Access Compliance Report

Public Rights-of-Way

(Curb Ramps)

Intersection ID: 24485	Main Street: CAMAROSS_DR	Cross Street: SAINTFIELD_PL	Location: NW
ADA ID: DDA23E825517	Ramp Type: Perp	Initial Pass/Fail: Fail	Overall Compliance: No
Severity Score: 8.75			
Codes/Mitigation Info/Possible Solution		Field Measurements/Component Compliance

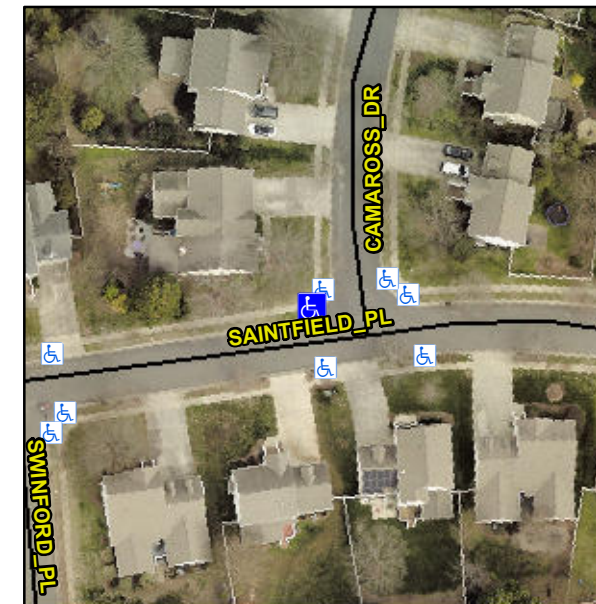
Not Found, R304.5.1

Compliance	Description	Data	Compliance	Description	Data
N/A	Ramp Length (in)	45.0	Yes	Ramp Slope (%)	6.7
No	Ramp Width (in)	45.5	Yes	Ramp XSlope (%)	1.5
N/A	Flare Type LT	N/A	N/A	Flare Type RT	N/A
N/A	Flare Slope LT (%)	N/A	N/A	Flare Slope RT (%)	N/A
N/A	Flare Traversable LT?	N/A	N/A	Flare Traversable RT?	N/A
N/A	Landing Length (in)	N/A	N/A	DWS Provided?	N/A
N/A	Landing Width (in)	N/A	N/A	DWS Contrast?	N/A
N/A	Landing Slope (%)	N/A	N/A	DWS Length (in)	N/A
N/A	Landing X Slope (%)	N/A	N/A	DWS Full Width?	N/A
N/A	Landing Curb? (Y/N)	N/A	N/A	DWS Offset (in)	N/A
N/A	Shared Landing?	N/A			
N/A	Gutter Ponding?	N/A	N/A	Gutter Slope (%)	N/A
N/A	Gutter Lip Ht (in)	N/A	N/A	Gutter X Slope (%)	N/A
N/A	Painted X Walk1?	No	N/A	Painted X Walk2?	N/A
	X Walk 1 Direction	To S		X Walk 2 Direction	N/A
N/A	X Walk 1 Width (in)	N/A	N/A	X Walk 2 Width (in)	N/A
	X Walk 1 Slope (%)	3.2		X Walk 2 Slope (%)	N/A
	X Walk 1 X Slope (%)	0.7		X Walk 2 X Slope (%)	N/A

Remove & Replace Entire Ramp.
